AN EVALUATION OF UNISOLATED LOCA OUTSIDE THE DRYWELL  
IN THE SHOREHAM NUCLEAR POWER STATION

D. ILBERG AND N. HANAN

LILCO Comments on Preliminary Review of Shoreham PRA Study  
Shoreham Nuclear Power Station  
Docket No. 50-322

FIGURE 1 Conceptual Representation of CET Binning Process

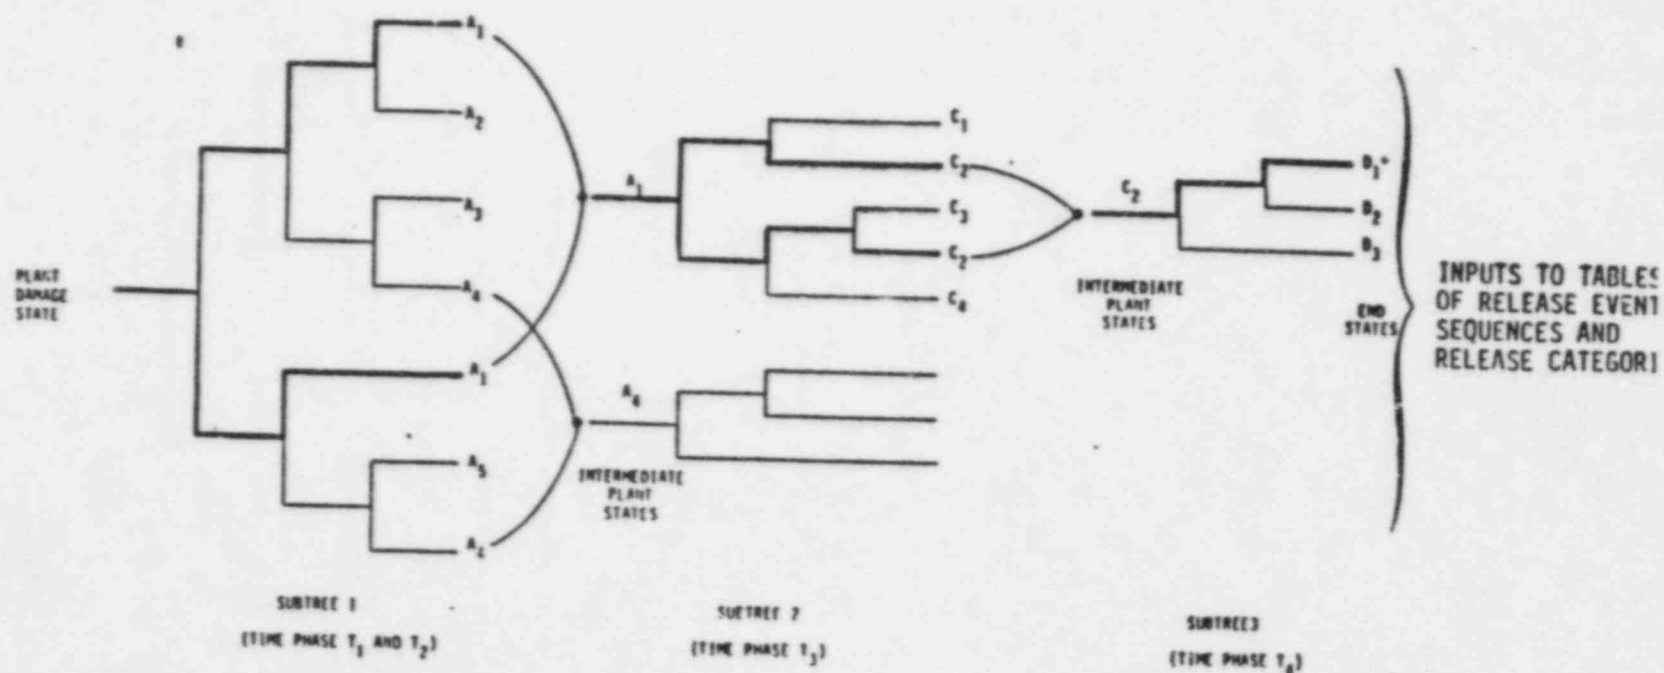
The basis for binning into release categories is poorly described and the transfer from Tables H4-6 etc. into the 16 release categories is difficult to interpret. A table listing the specific sequences which are binned into each category should be provided.

A perspective of the CET binning process may be obtained from Figure 1. This provides a graphical description of the CET development into sub-trees and the procedure used to collapse the sequences which were judged to have similar characteristics, in terms of the release potential. As the figure indicates, the "binning" occurs at critical pinch points of the CET.

It was necessary to perform the CET evaluation in this manner to limit the propagation of hundreds of possible end states which in the end would have to be grouped in order to make the quantitative analysis more manageable.

A sequence, therefore, may be designated by a series of intermediate plant states and end states, the progression of which can be determined by examining the subtrees of the CET separately. Those sequence designators assigned to characteristic accident class release events, for example,  $C_1R_4T_1$ -DW for class 1, are shown in Figure H.4-8.

FIGURE H.4-2 CLASS I CONTAINMENT EVENT TREE TIME PHASES T<sub>1</sub> AND T<sub>2</sub>  
(SHEET 1 OF 11)

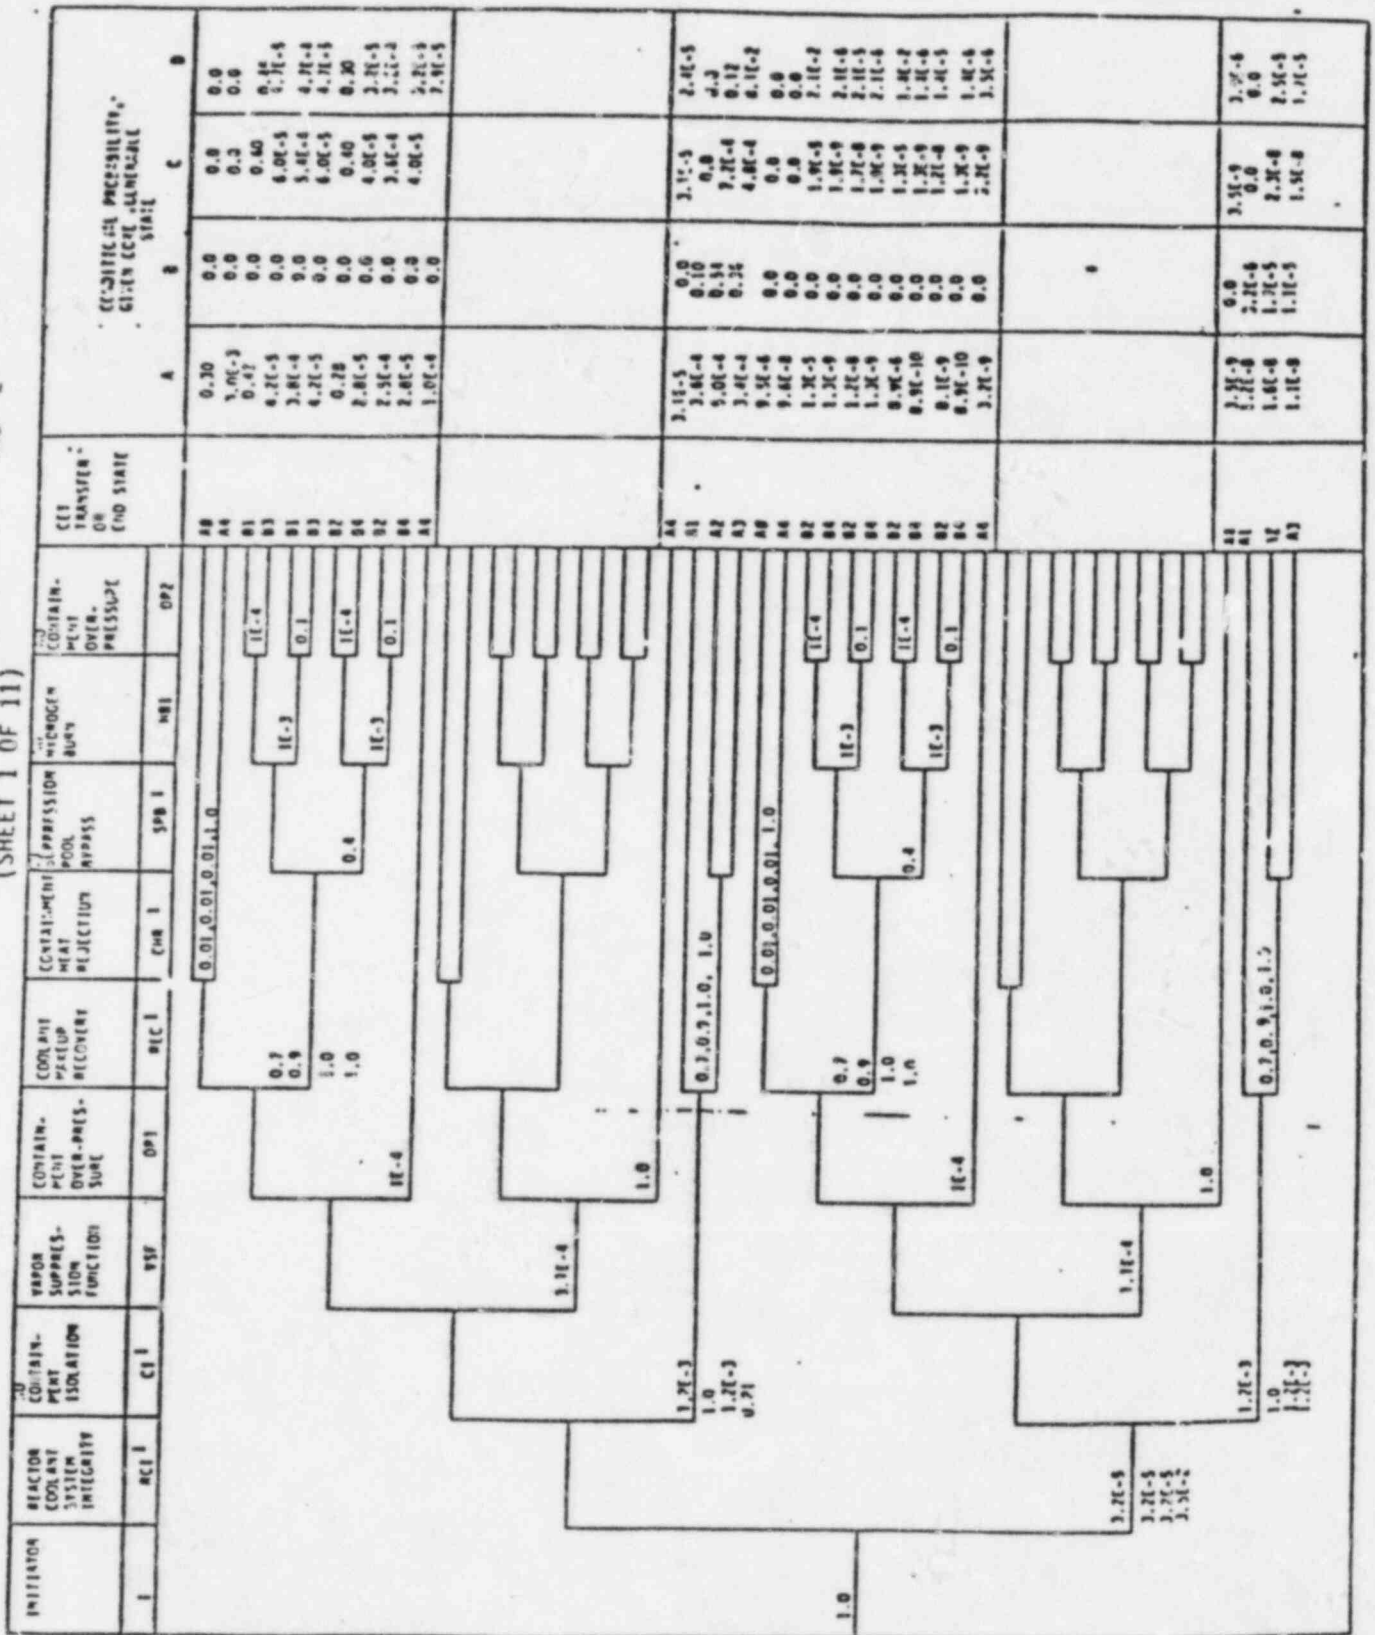
Sheet 1 of Figure H.4.2 has been reduced so that is illegible. A full-size legible copy should be provided.

Attached is a full size legible copy of Figure H.4.2. sheet 1 the Containment Event Tree for Class I Time phases  $T_1$  and  $T_2$ .

POWER INDUSTRY GROUP		TITLE		SCALE 1/4" = 1'-0"	
CHECKED		PLAN EL 62-3		DATE JUNE 3, 1983	
CORRECT	PCW	REACTOR SUPPORT ALL		SKETCH NUMBER	
APPROVED				PFA-1	
REVISIONS	(2)	(3)	(4)	(5)

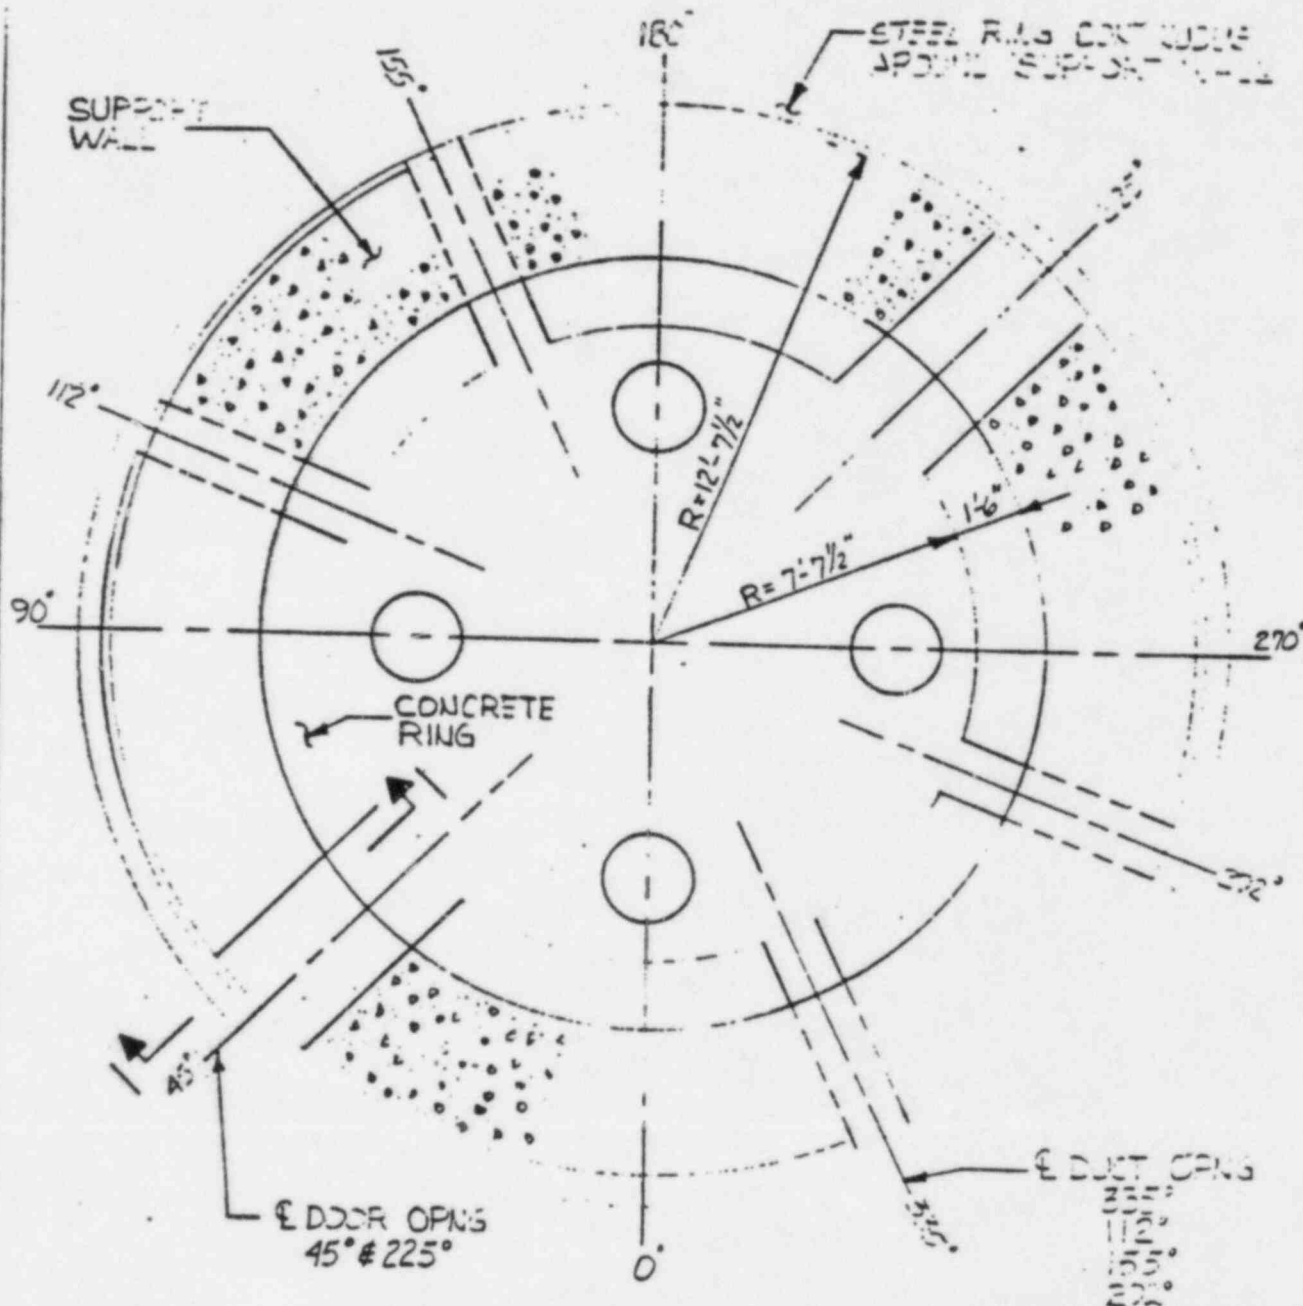
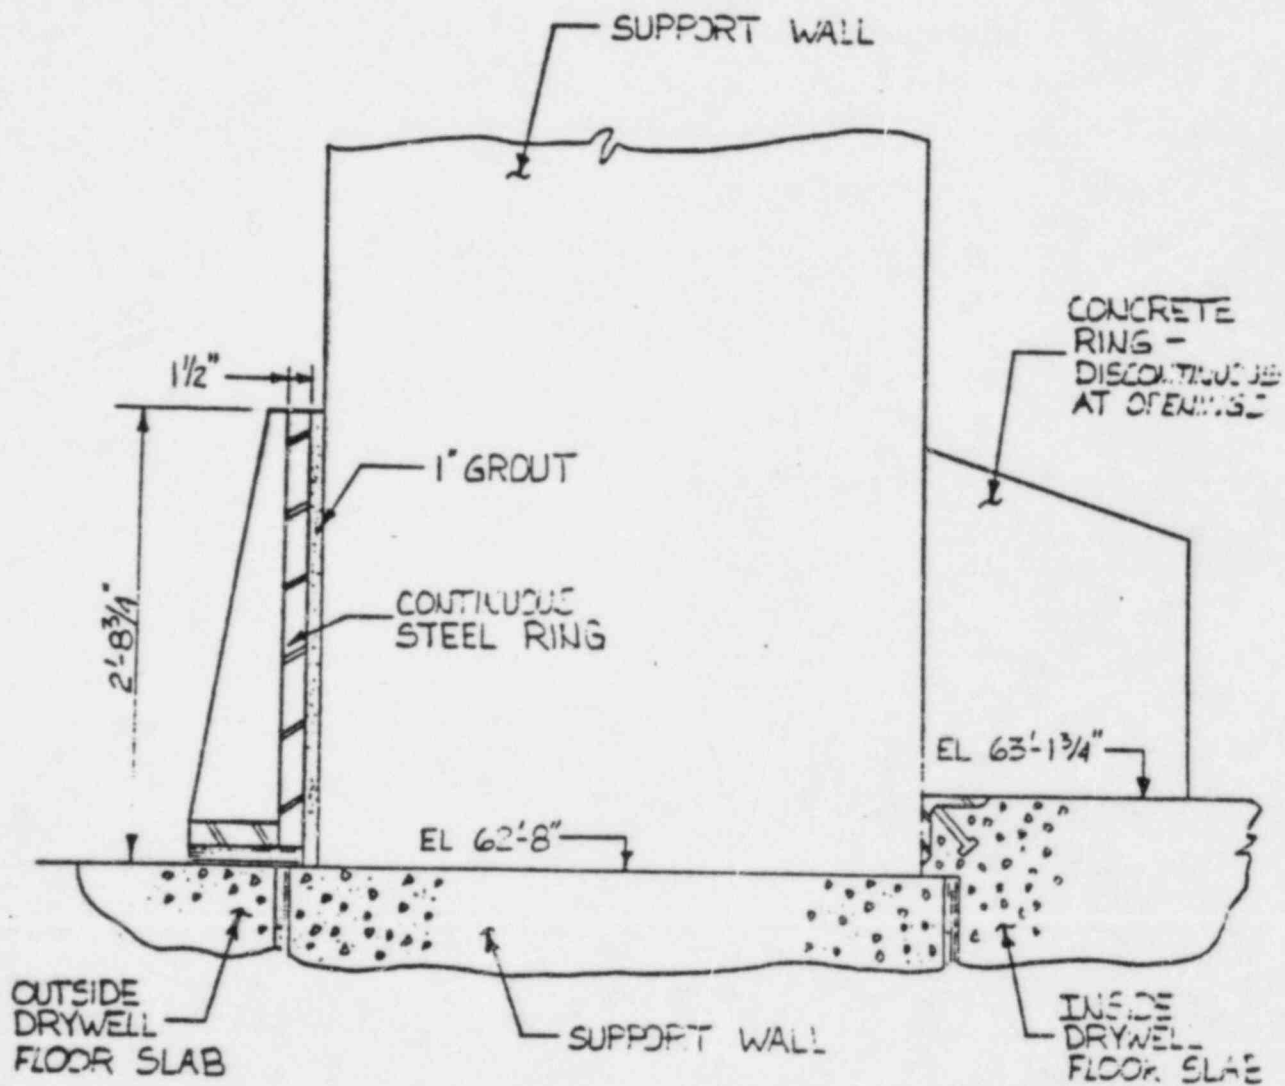
Appendix L provides a detailed discussion of the disposition of the corium (90% is expected to go down the vent pipes) based on the revised reactor pedestal geometry illustrated in Figure L.3-2. However, this figure is inconsistent with other descriptions of the geometry (e.g., Figure 2.3-2) and provides inadequate information for an independent assessment of the corium disposition. Please provide detailed (as built) drawings of the vent pipes and their covers within and external to the reactor pedestal region. Include a description of whether the air ducts and manways in the reactor support wall will be blocked during operation.

Figure 2.3-2 was included within the body of the PRA to provide a general arrangement of the Shoreham Primary Containment. The scale at which this figure is drawn does not lend itself to providing any level of detail that would support an assessment of corium disposition. Figure L.3-2 however, is drawn to a scale that provides a level of detail that could not be included on a small scale drawing such as Figure 2.3-1. Figure L.3-2 provides as-designed dimensions and elevations for a section thru the reactor support wall at one of the four air vents. Variation from these dimensions and elevations would only be affected by very nominal construction tolerances.

For clarity and as an aid to assessing corium disposition, additional figures have been developed. Figures PRA-1 and PRA-2 provide details through the support wall manway openings.

Corium disposition through this opening is blocked by the continuous steel ring around the outside of the support wall. Additionally, drawings 11600.02-FP-4B, 18C, 18D and 18L are provided. These drawings show the final arrangement of the downcomers and their covers both inside and outside of the support wall. Drawing FP-4B depicts the downcomer geometry outside the pedestal region. Drawing FP-18L (detail 28-28) shows the configuration inside the pedestal with the raised floor almost flush with the downcomer lip.

As depicted in the PRA, the segmented concrete ring is planned to be made continuous at the air vents and removable concrete walls are planned to be placed in the manway region. This proposed modification will further enhance this unique feature of the Shoreham containment.
